To: INCITS Technical Committee T10  
From: Fred Knight, Network Appliance  
Email: knight@netapp.com  
Date: Nov 17, 2008  
Subject: SBC-3 Thin Provisioning Commands

Revision 5 (Nov 17, 2008)

Create unmap operation used by UNMAP command, create lists from several long sentences, propose specific ASC/Q values, update the PRE-FETCH command, add the REASSIGN BLOCKS command behavior for unmapped LBAs, clarify the VERIFY command.

Figure B – Logical Block State Transitions

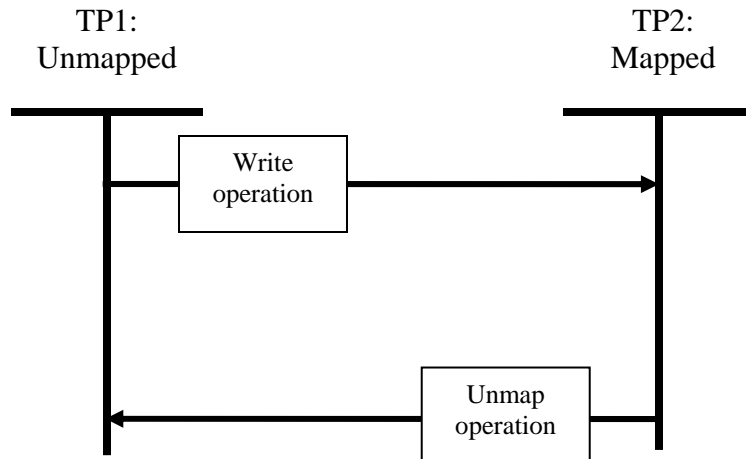
Transitions between the mapped and unmapped state are shown in figure b.

##### 4.4.1.2.1 Transition TP2:Mapped state to TP1:Unmapped state

This transition occurs when an unmap operation completes without error (see 4.4.1.5.2). As a result of this transition, the user data retrieved by the next read operation or verify operation is indeterminate.

#### **4.4.1.3.1 Transition TP1:Unmapped state to TP2:Mapped state**

This transition:

- a) shall occur when a write operation completes without error. As part of processing a write operation, the device server may cause LBAs other than those specified by that write operation to transition from unmapped state to mapped state; or
- b) may occur at any other time for vendor specific reasons.
